# Product Change Notification

Product Change Notification: E-16-014616

AMPMODU MTE HEADERS GPL 296

**Change in circuit cavity features**

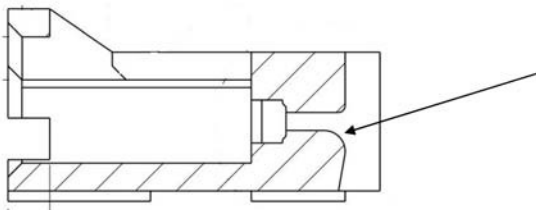
To satisfy customer demand for the capability of MTE headers to handle RoHS solder temperatures, TE Connectivity has retooled the MTE header product line to use high temperature compatible LCP molding material. These changes will result in the following product changes: 1) Housing material will change from high temperature nylon to LCP. 2) The header housing width will be reduced by 0.005 inches to accommodate the assembly process. 3) In order to consolidate some housing features, the contact cavity configuration will be changed slightly as shown in the attached sketch.
